**CITY OF BOULDER
PLANNING BOARD AGENDA ITEM
MEETING DATE: October 15, 2015**

AGENDA TITLE: Public hearing and consideration of Site and Use Review applications for expansion of the Meadows Tennis Club located at 5555 Racquet Ln. within the RL-2 zone district. The proposal includes the renovation and expansion of the existing clubhouse including enclosure of two existing tennis courts adjacent to the clubhouse; relocation of two existing platform tennis courts and the addition of two new platform tennis courts and two new tennis courts. The applicant is requesting a 39% parking reduction to allow for 92 parking spaces where 151 are required following the proposed expansion. The project is reviewed under two separate cases, LUR2014-00095 and LUR2015-00018.

Project Name: Meadows Club Expansion

1 SITE PLAN
A1.1 1" = 40'-0"

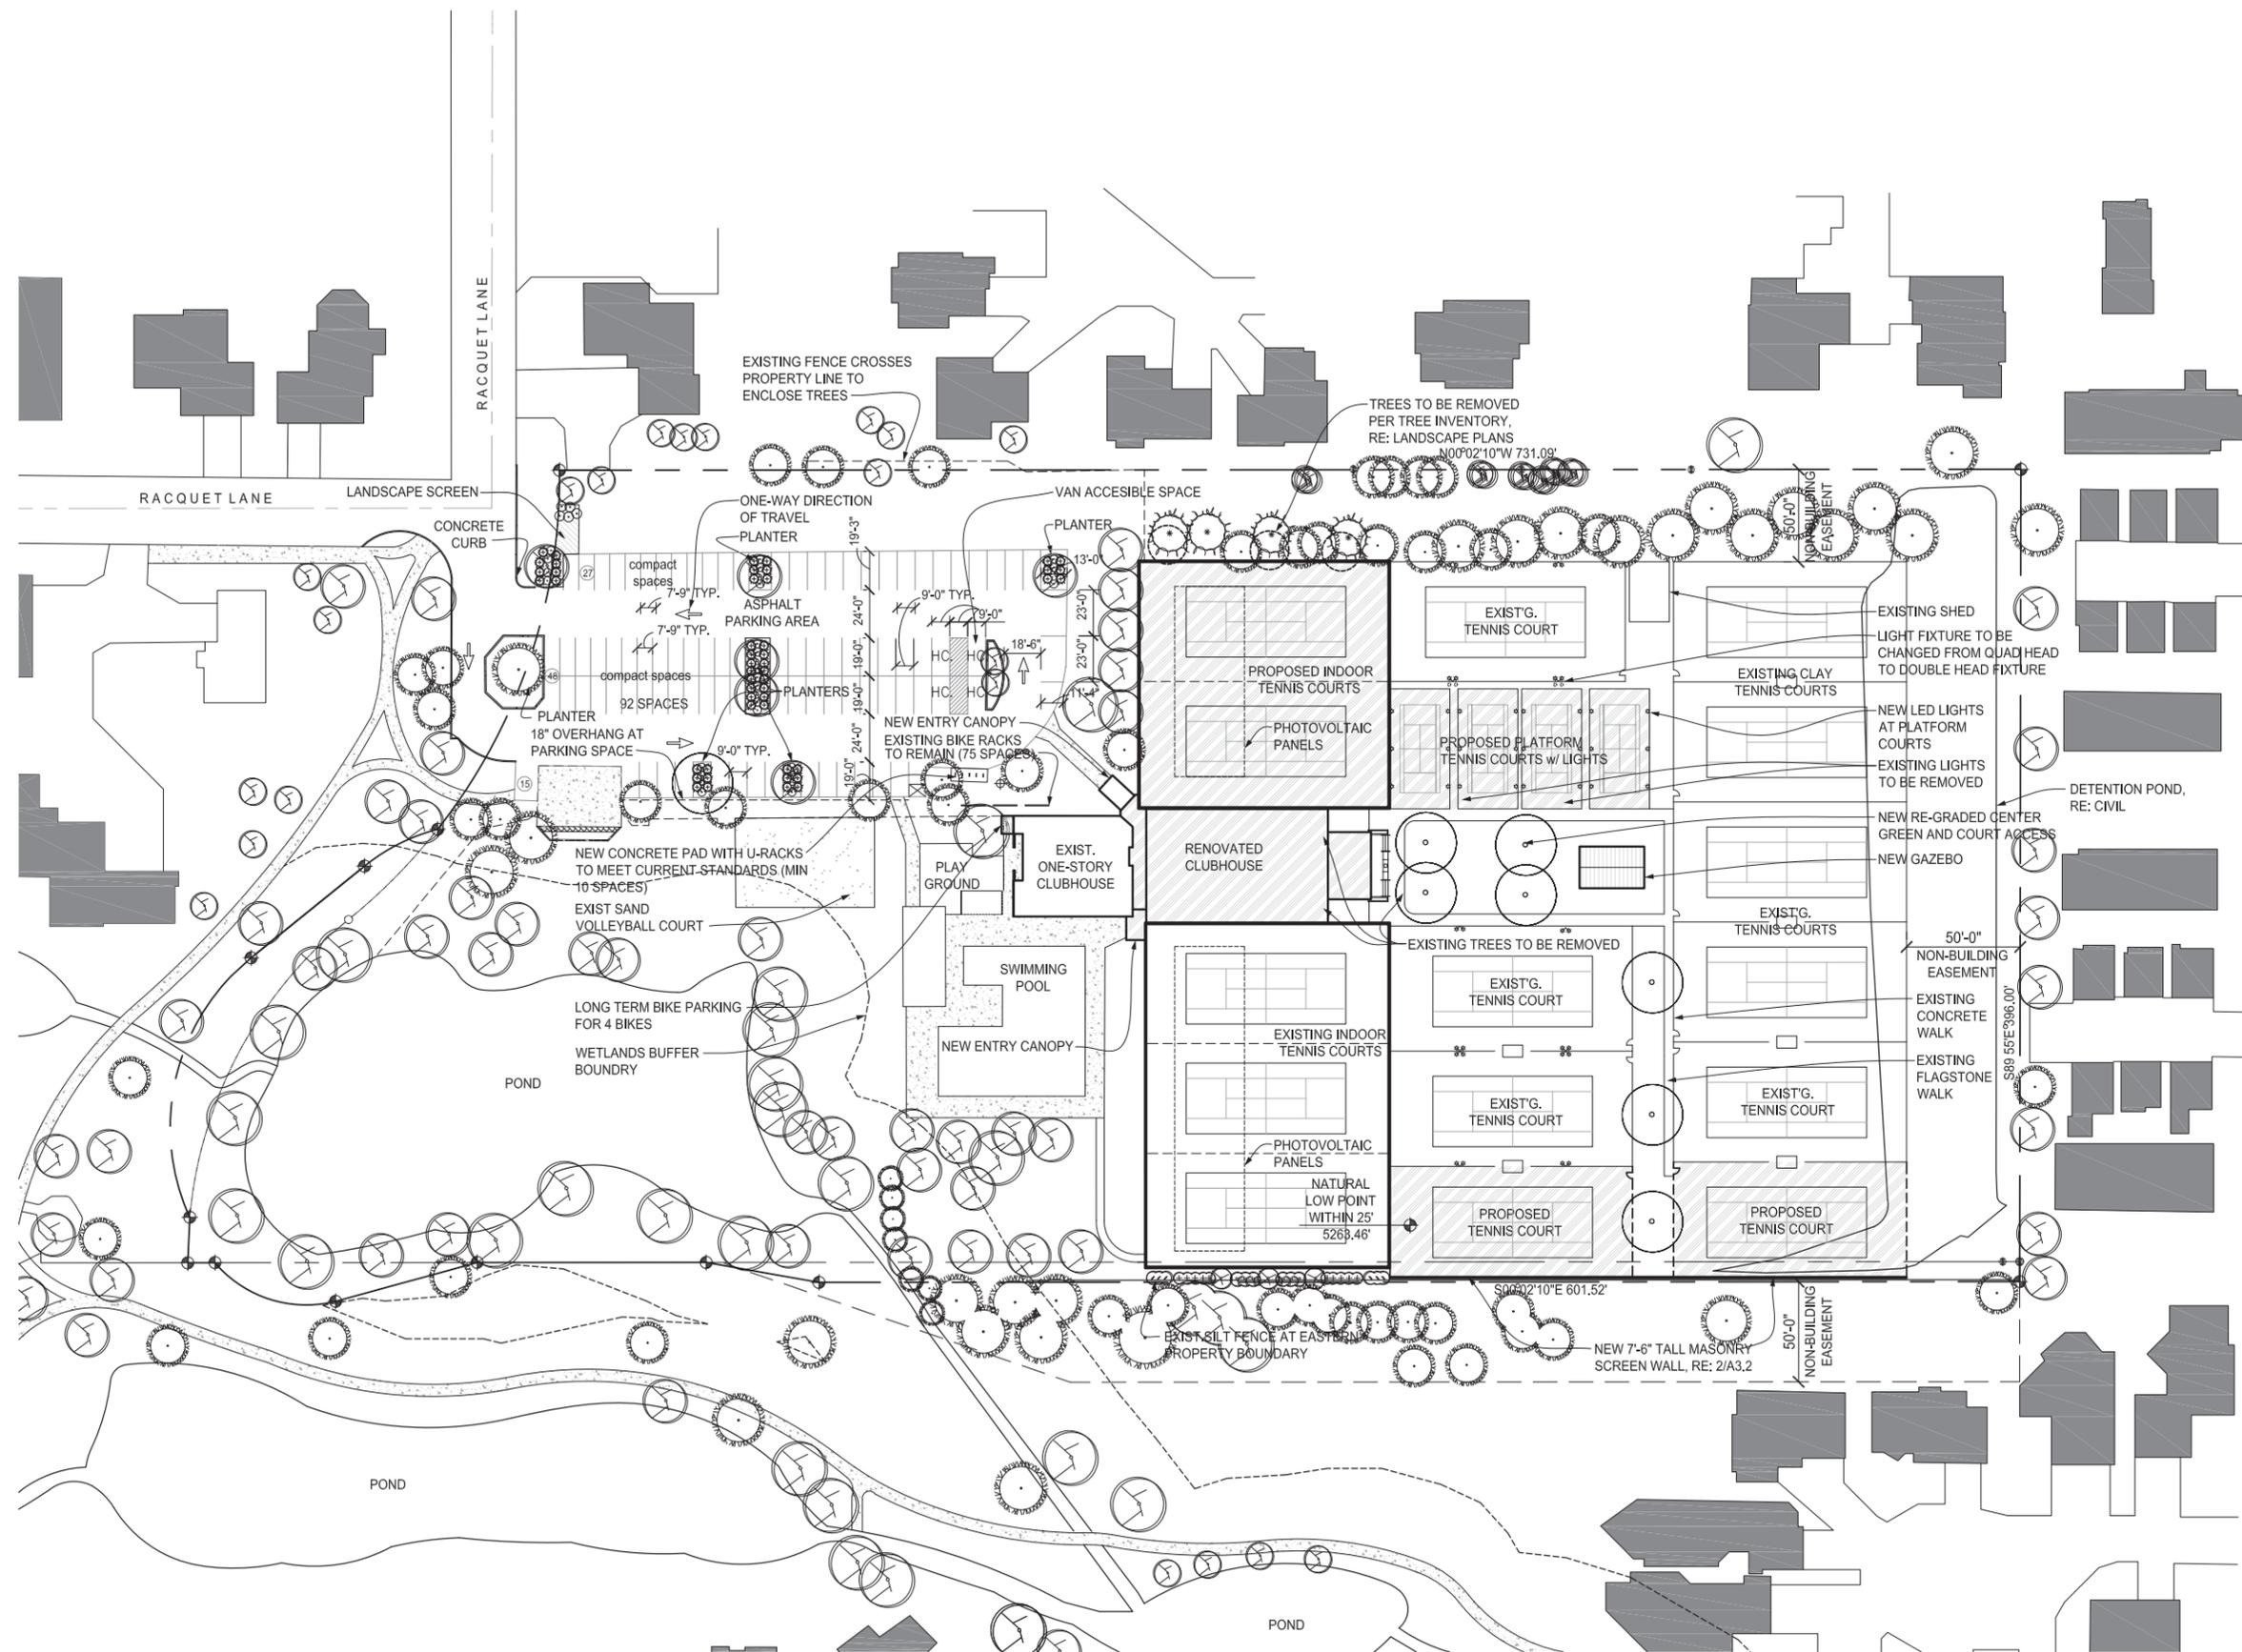
5. Staff previously commented on the existing wooden fence near the western property line adjacent to the parking lot. Based on sheet A1.1 the fence shifts from the Meadows property to the adjacent home owners'. In the event this fence is removed in the future, parking lot screening pursuant to subsection 9-9-14(c), B.R.C. 1981 will

2) The Notice does not mention the proposed construction of two new "regular" tennis courts in the northeast corner of the property (mislabeled as the southeast corner). This additional expansion can be seen in Map A1.1 on [07 Site Plans Meadows.pdf](#) (lower right corner). The Notice mentions construction of new _platform_ courts, and relocation of existing platform courts, but does not mention the construction of two new regular courts.

3a) The proposed new courts in the northeast corner, as shown in Map A1.1 on [07 Site Plans Meadows.pdf](#) (lower right corner; mislabeled as southeast corner), will directly abut the property line separating the Club and the adjacent Meadow Glen Residents Association (MGRA). That is, the Club is proposing "zero lot line" building. Is such "zero lot line" building legal and appropriate for the Club's RL-2 zoning and location within a residential community?

3c) Map A1.1 on [07 Site Plans Meadows.pdf](#) denotes a "50-foot non-building easement" separating the proposed new courts (in the northeast corner, mislabeled as the southeast corner) from the residential properties to the east (mislabeled as the south). Labeling this land as an "easement" is completely misleading. The "easement" language stems from the original 1976 PUD (Everett/Zeigel Associates), however the site plan for this PUD assumes that the Club and the adjoining MGRA are part of the same property. This is not the case -- the MGRA is an entirely separate, and separately-owned, entity from the Club. The alleged "50-foot non-building easement" as shown on the Club proposal is wholly owned by the MGRA, entirely within the MGRA property line. The Club has no legal ownership of, interest in, nor control of this MGRA property, and the land is in no way an actual, legal easement.

2 BLOCK WALL DETAIL
A3.2 3/4" = 1'-0"

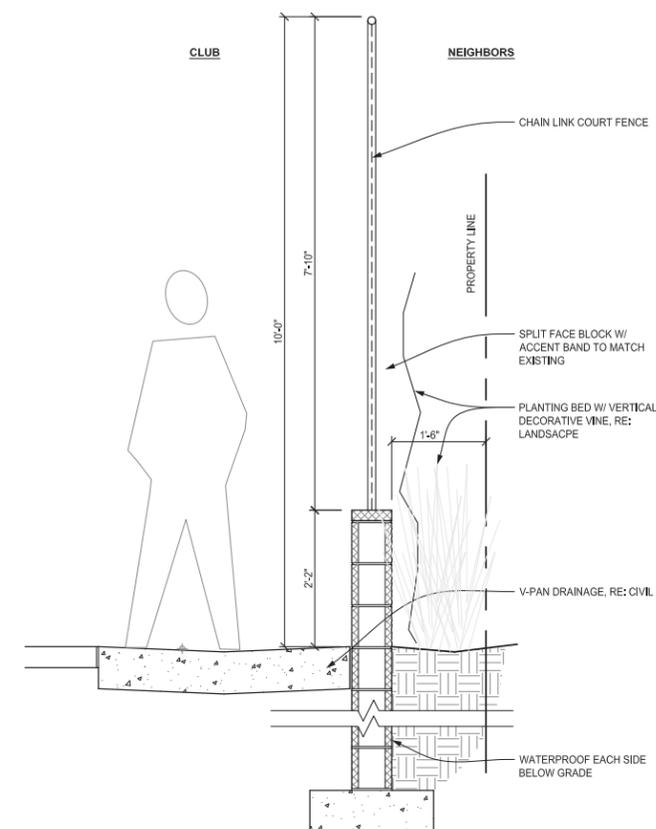
6. The Block Wall Detail (sheet A3.2), shows the width of the proposed gutter drainage pan inconsistent with the Civil Engineering plans. The proposed design of the pan per the civil drawings is a shallow concrete v-channel 4 feet wide, however, the detail shows a channel approximately 16" wide if scaling from the reported dimensions or 8 feet wide if using the scale as labeled. Revise plans and scale label as necessary.
